REQUEST FOR PROPOSAL

Project Title: Cooley Laboratory Renovation
Location: Montana State University

PPA No.: 10-0023
RFP No.: 70
Date: September 11, 2012

LANDSCAPING AND IRRIGATION NORTH OF TAYLOR HALL

TAYLOR HALL IRRIGATION  
CRU 8-13-2012

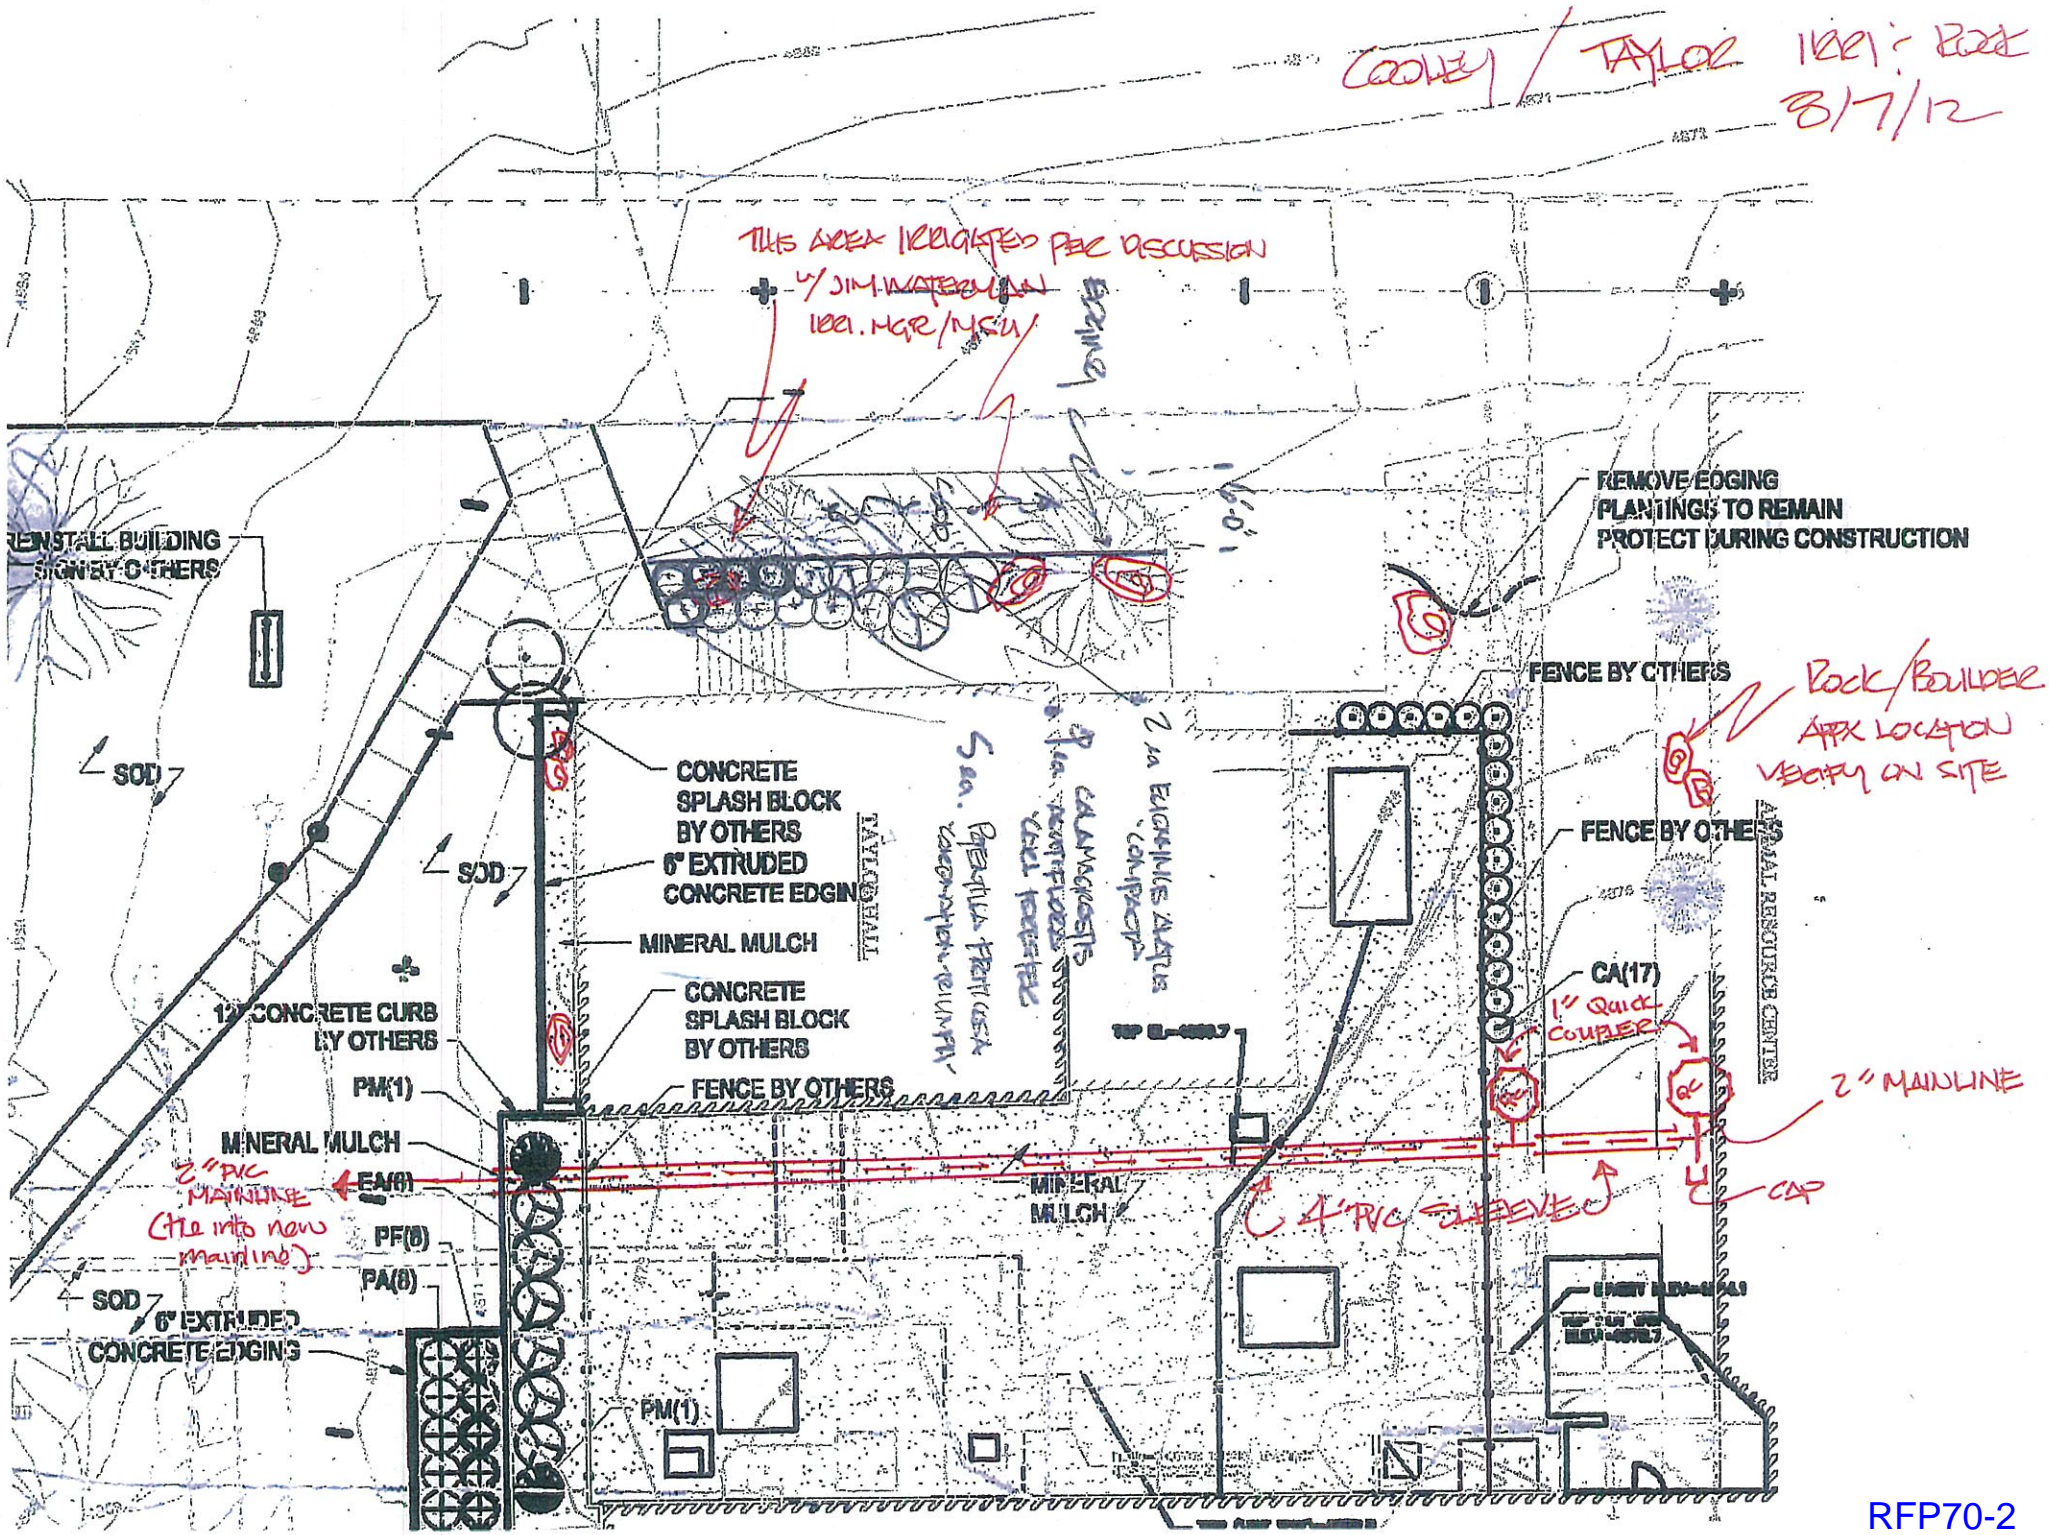
Scope of work includes; 2810 Irrigation System 2210 Tree Protection -2900 – Landscaping 2935 – Lawns & Grasses

- Provide Weed barrier – Bark – Plants and Boulders as shown
• 2” Irrigation mainline through 4” PVC sleeve through mechanical yard north of Cooley with 1”quick couplers
• Provide Irrigation as shown on attached sketch “ Taylor Hall Irrigation”

DELETE SLEEVE  
AT SOD AREA

DELETE  
SLEEVE, PIPE,  
AND HEADS

6 VAN RB 1840 HEADS  
VERIFY QUANTITY  
HEADS @ 5'-0" O.C.  
STAGGER/OFFSET FROM  
EACH OTHER

1" QUICK COUPLERS  
RB 33 QC.
